## STAR ONLINE PUBLICATION

**Case Number:** S1309000030 REV. A

**Symptom/Vehicle Issue:** Engine Oil Filter Interchangeability

**Figure 1.**

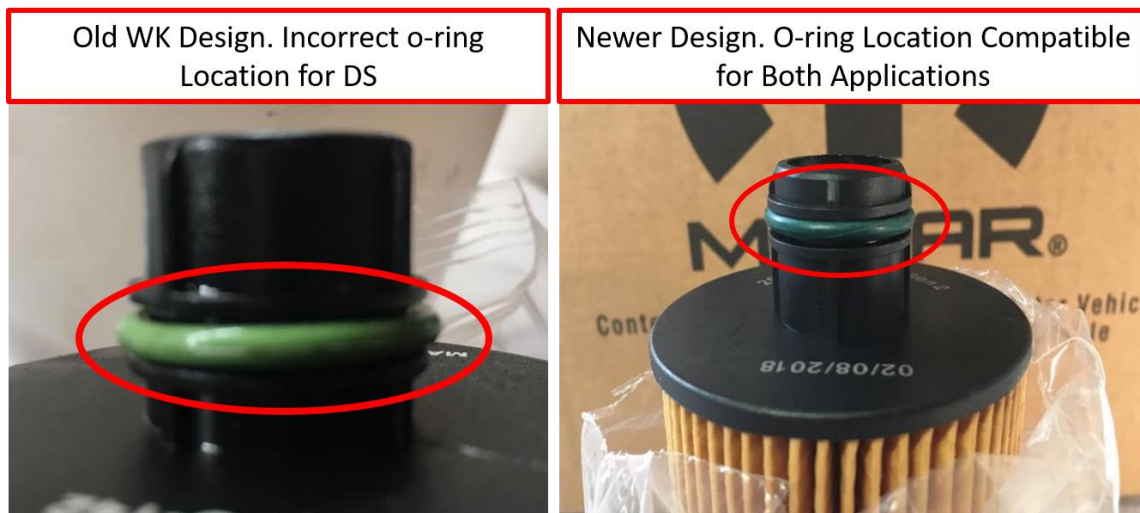
**Discussion:** When the GEN 2, 3.0L was launched in 2014, there were 2 different part number oil filters used based on vehicle application. Part number 68109834AA was for the WK Grand Cherokee applications, while part number 68229402AA was used on the DS Ram 1500. The reason behind the separate part numbers was due to the different oil filter housing drain back valve designs.

The differences between these 2 part numbers is the location of the sealing o-ring at the end of the filter cartridge. Please see (**Figure 1**).

To avoid mistakes of using the Grand Cherokee design filter in the Ram 1500, the original 68109834AA part number was discontinued, and we now use the same part number for both applications. However, it has come to our attention that some cheaper aftermarket filters available on the market are based on the older Grand Cherokee design, yet are being marketed as compatible for both applications. This is incorrect. Do not use any oil filter in the DS Ram 1500 3.0L engine that was originally designed for the WK Grand Cherokee application.
